BRIDGE REPLACEMENT - PPCB
NHSN-020-2(143)--2R-81

SAC COUNTY - DESIGN 116/216

EXAMPLE OF TITLE SHEET WITH 4 PLAN REVISIONS.

REVISION EXAMPLE

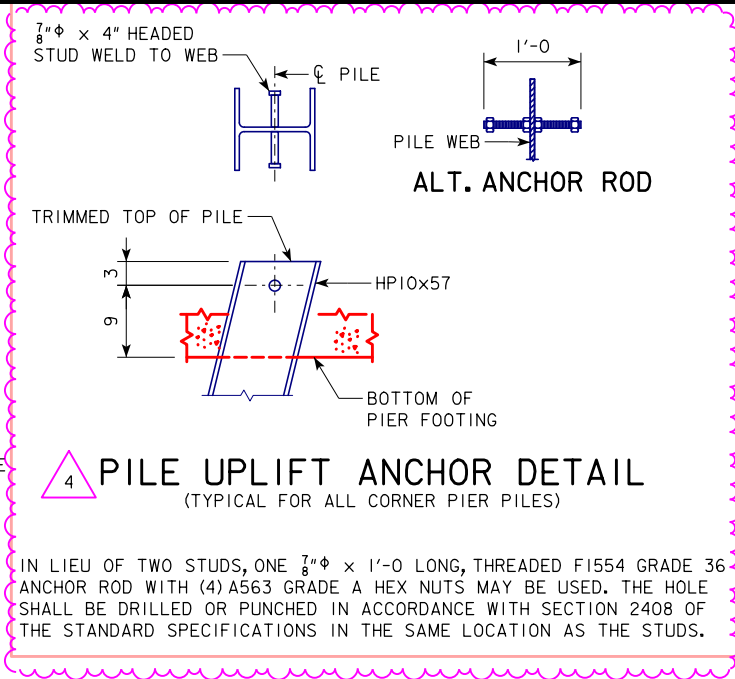
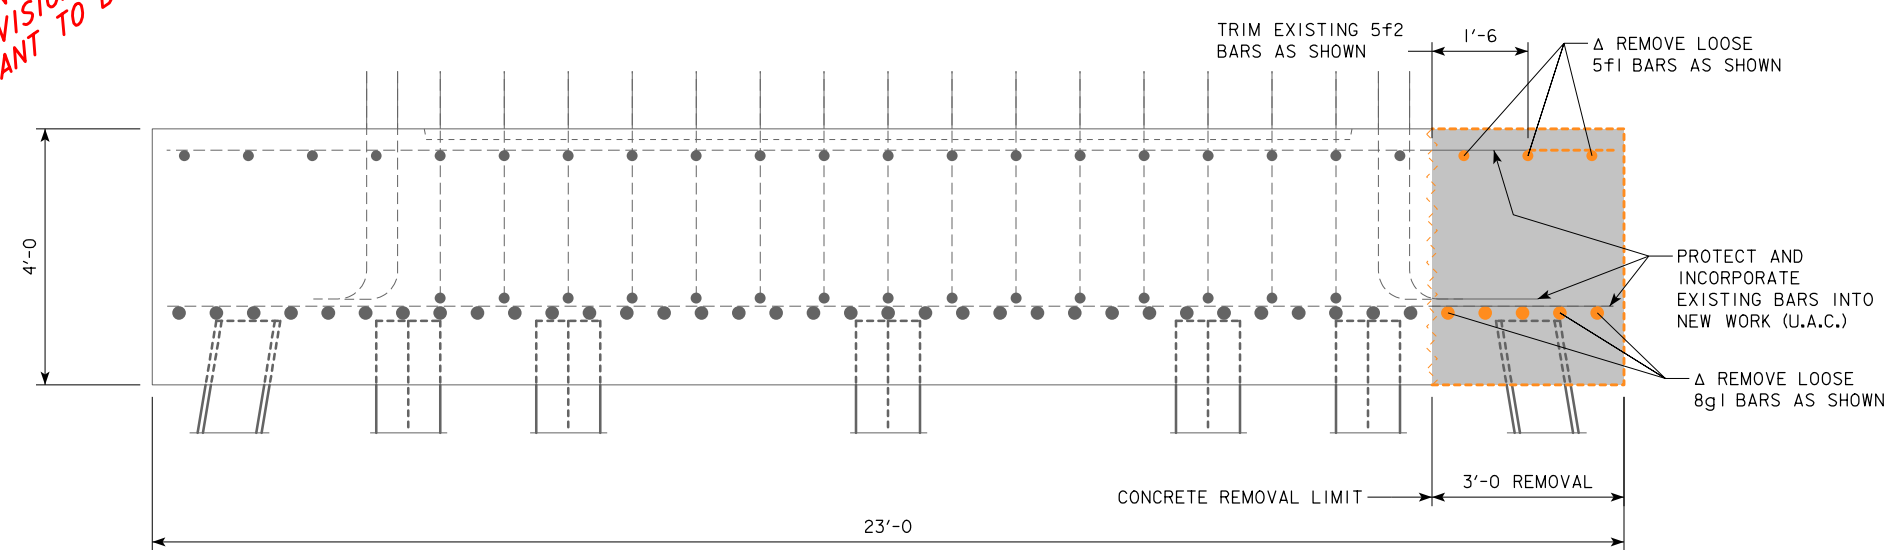
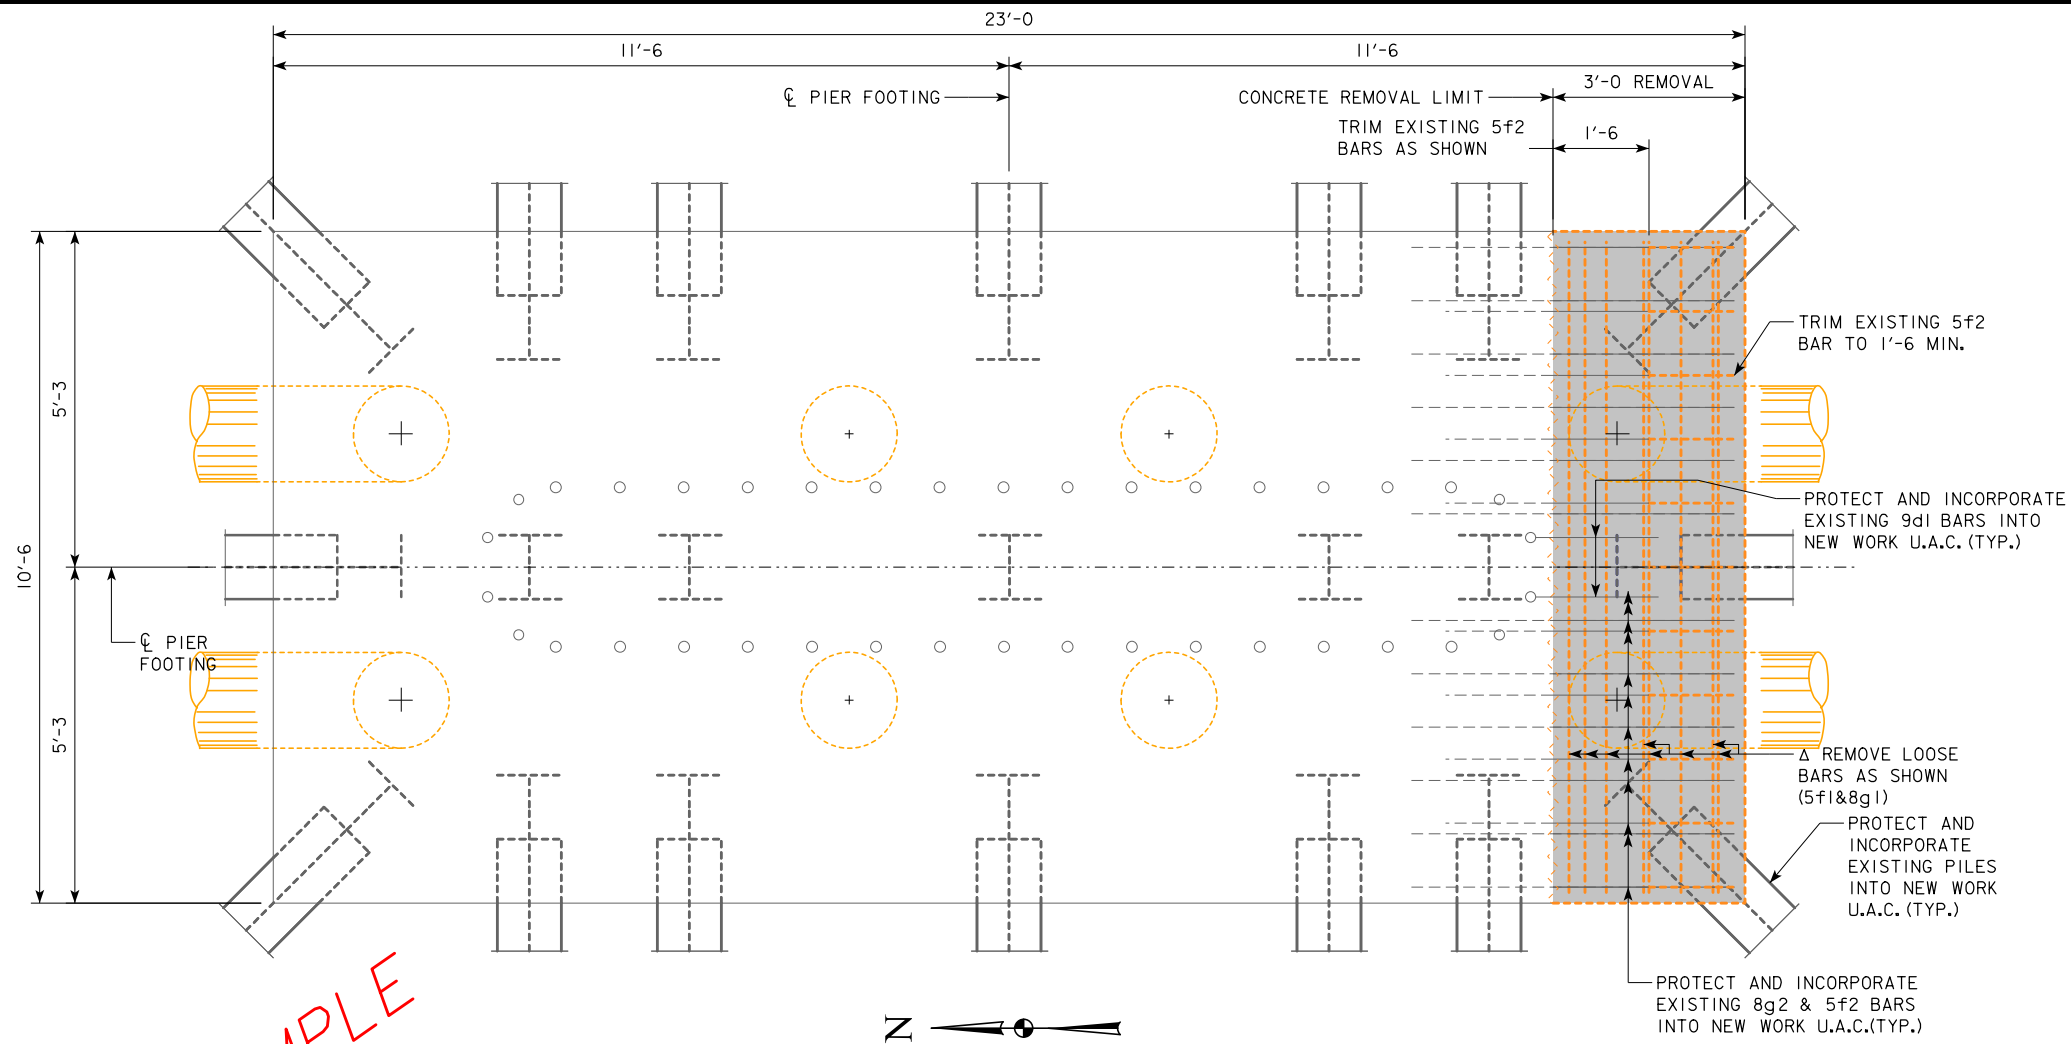
4 REVIS: 04-15-2017 PILE UPLIFT ANCHOR DETAIL ADDED.
 REASON: ANCHOR DETAIL NEEDED FOR ADDITIONAL REQUIRED PILES.

Δ LOOSE BARS 5f1 & 8g1 MAY BE CLEANED AND INCORPORATED INTO THE EXISTING FOOTING AS APPROVED BY THE ENGINEER.

1 REVIS: 03-09-2017 THIS SHEET ADDED.
 REASON: PIER 2 FOOTING MISPLACED 1.4 FT. NORTH OF PLAN ALIGNMENT DUE TO CONSTRUCTION SURVEY ERROR.

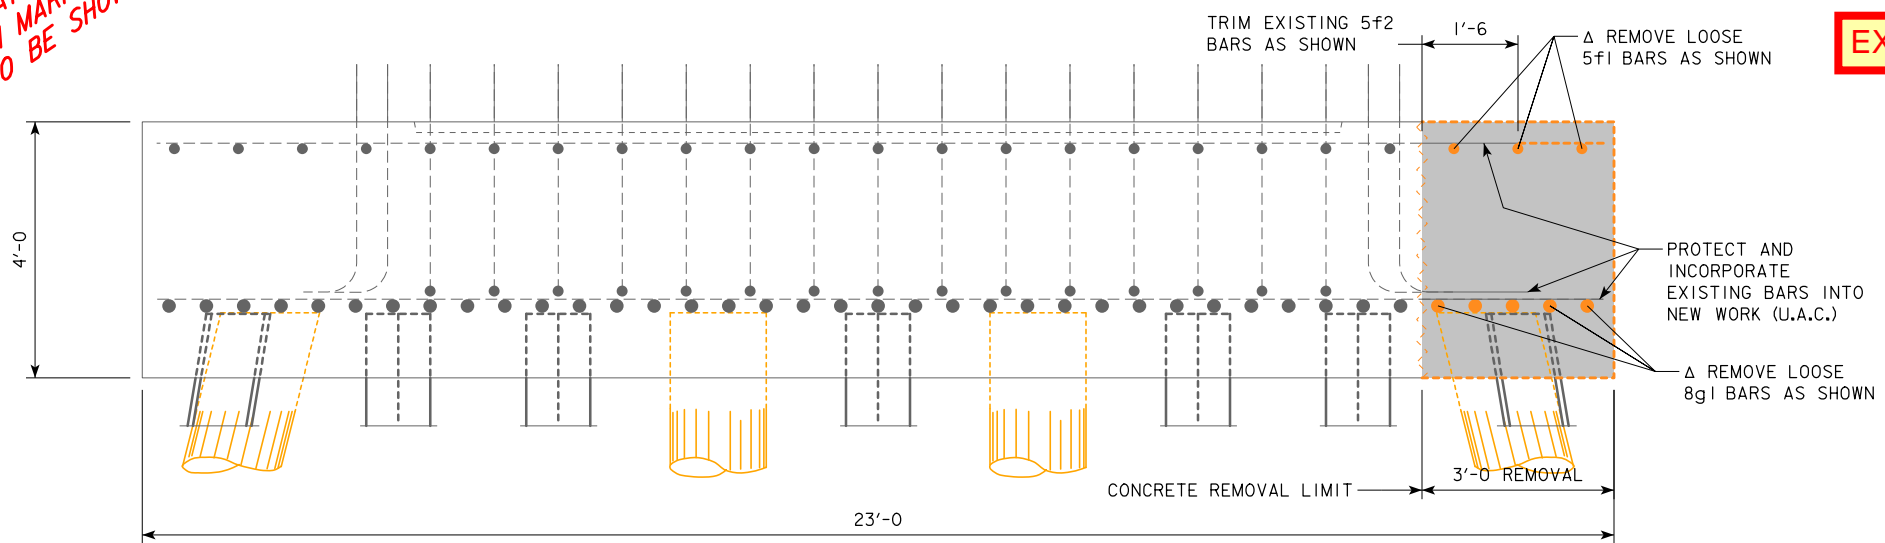
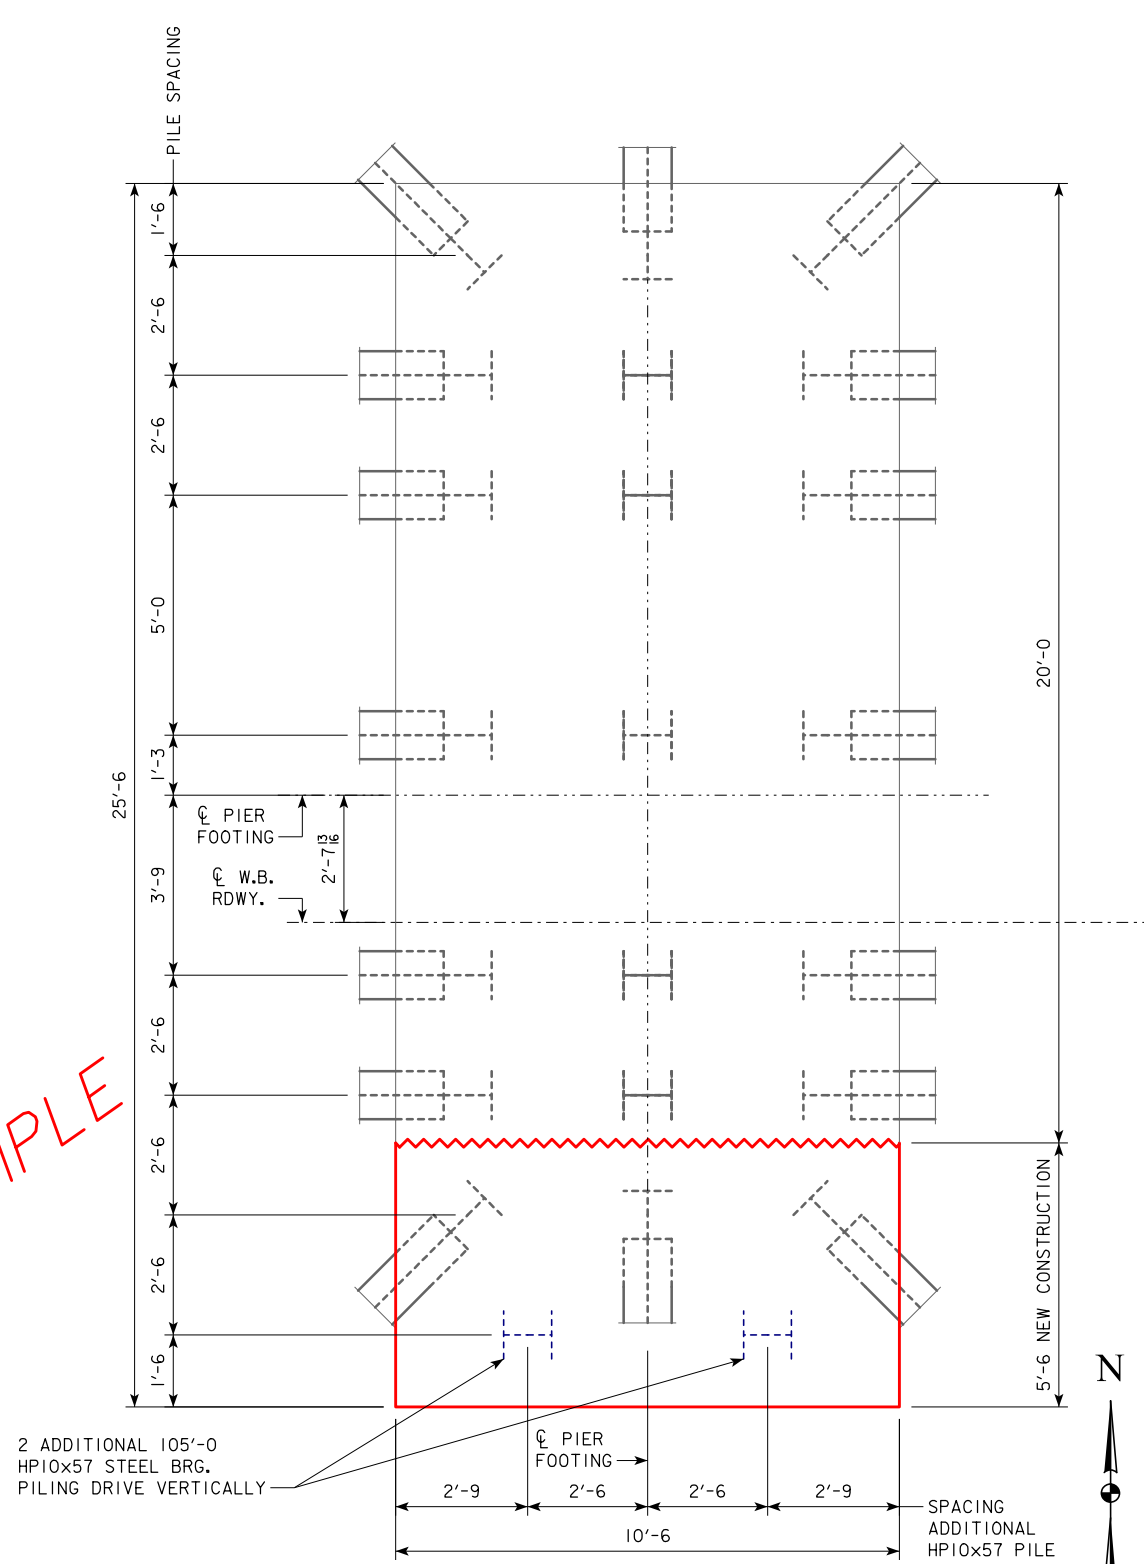
4 REVISION: 04-15-2017 THIS SHEET ADDED.
 REASON: WOOD PILES WERE ADDED TO FOOTING FOR ADDITIONAL SUPPORT.

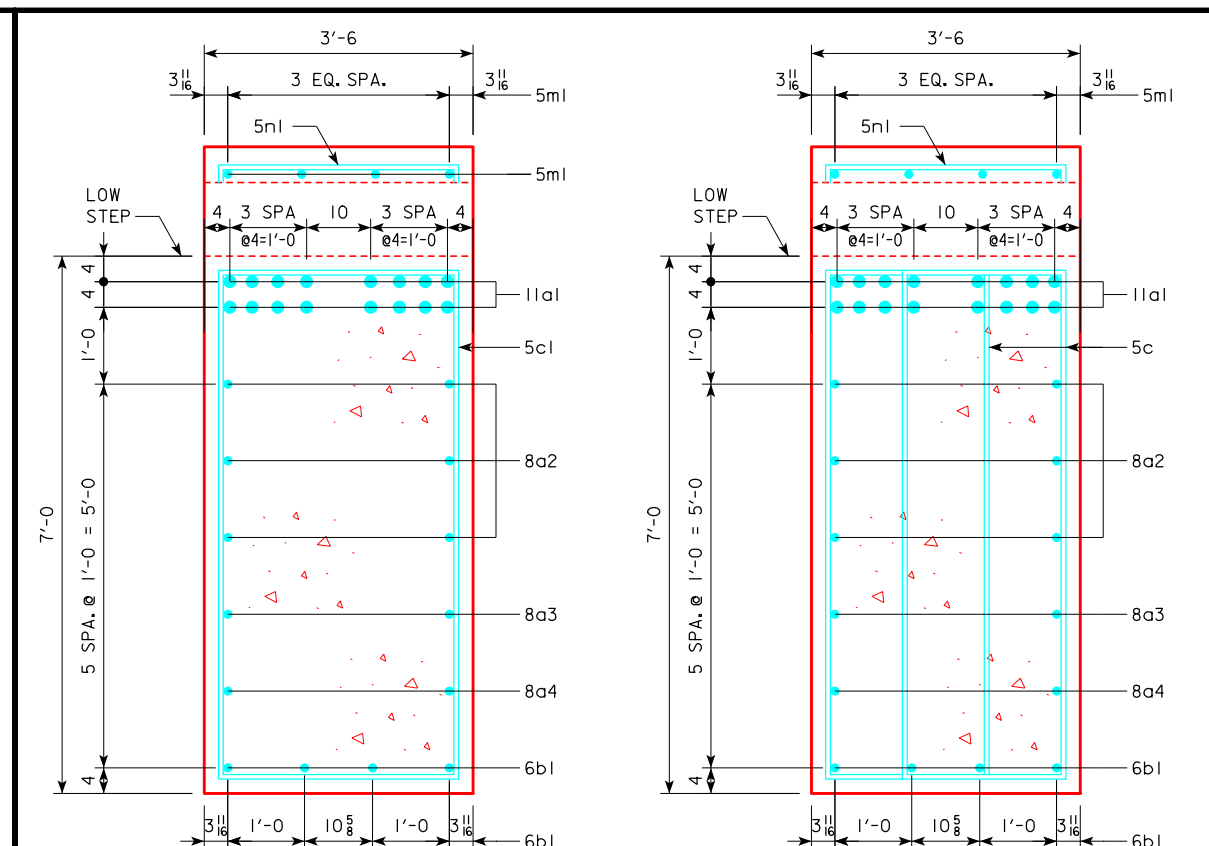
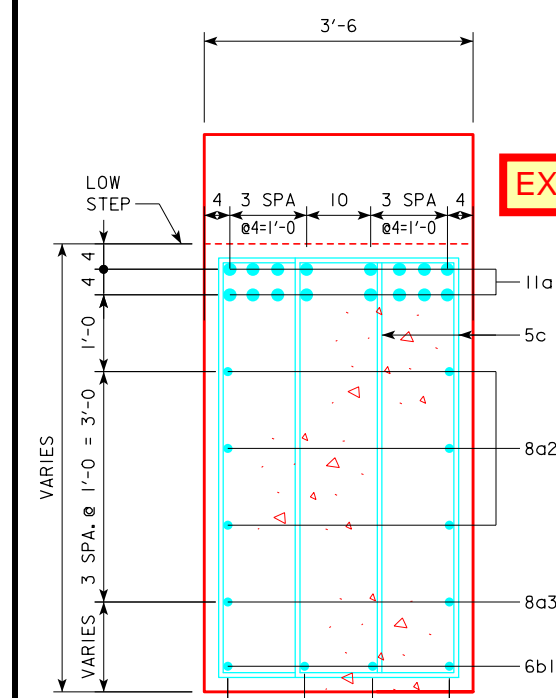
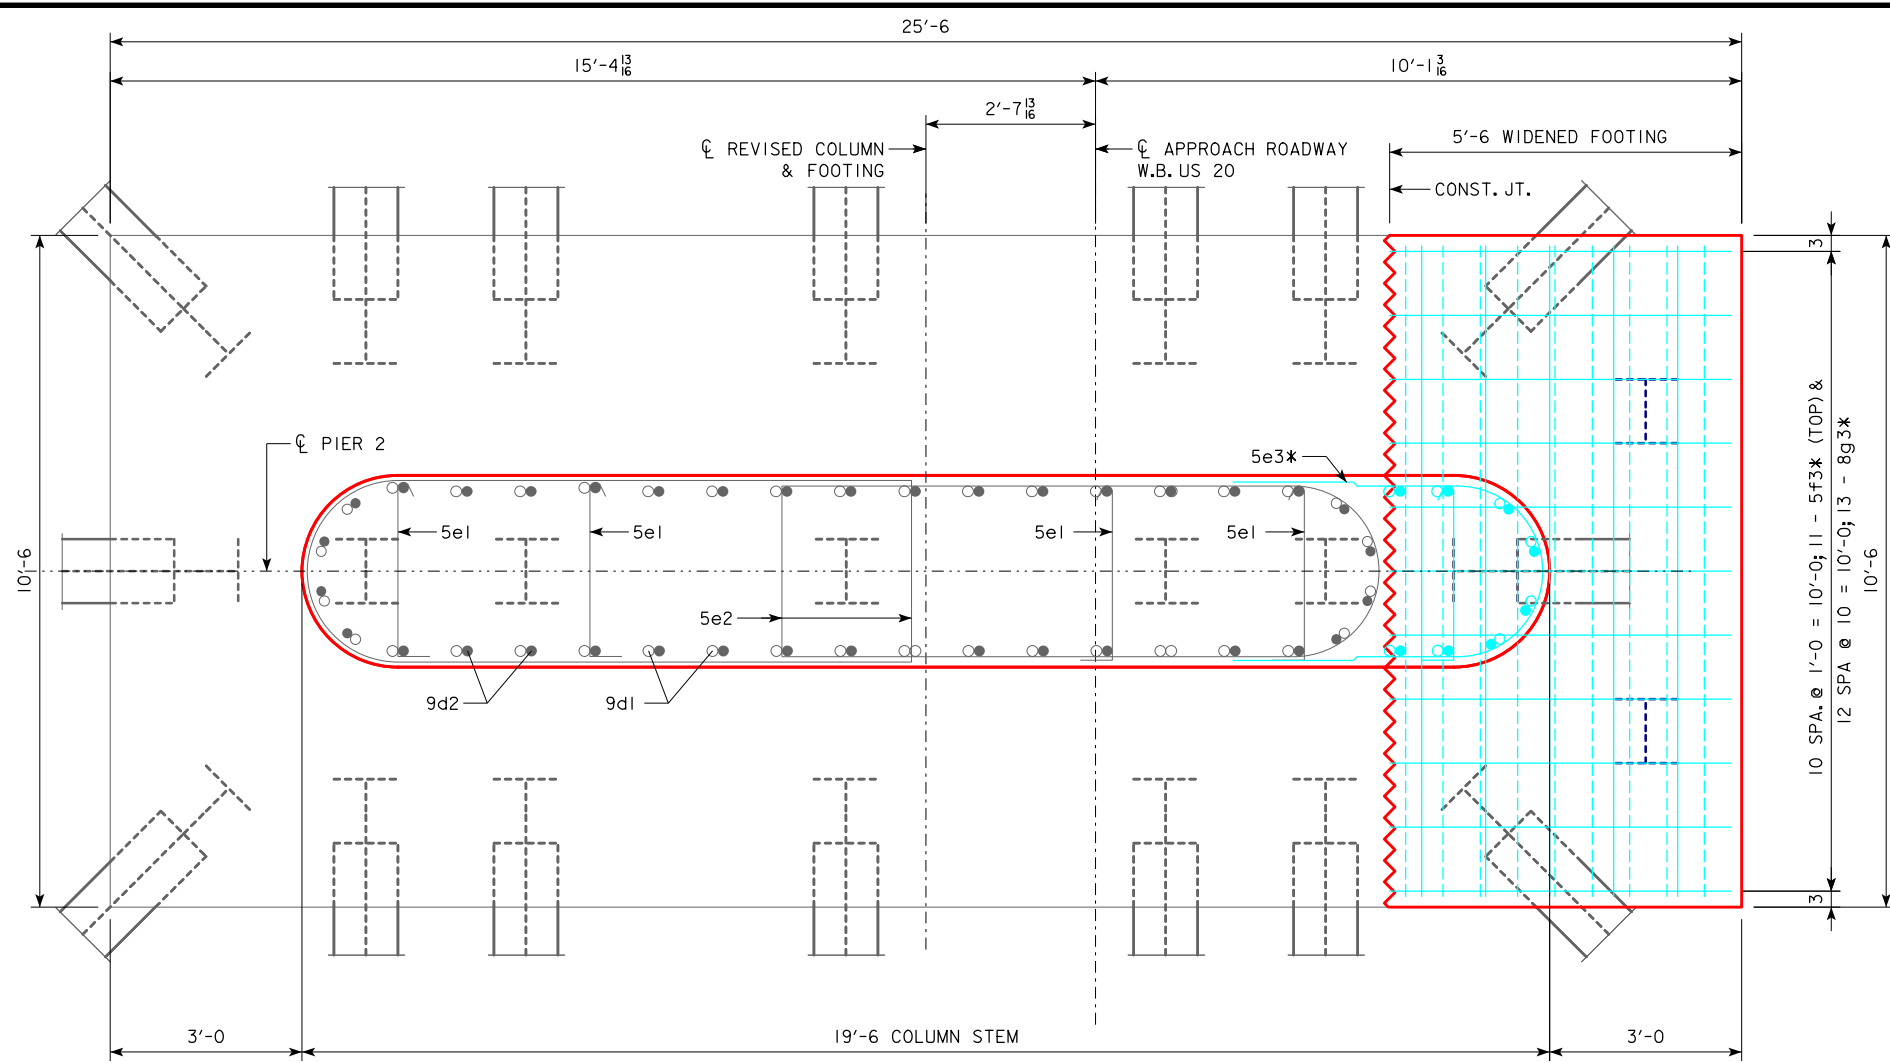
1 REVISED: 03-09-2017 THIS SHEET ADDED.
 REASON: PIER 2 FOOTING MISPLACED 1.4 FT. NORTH OF PLAN ALIGNMENT DUE TO CONSTRUCTION SURVEY ERROR.
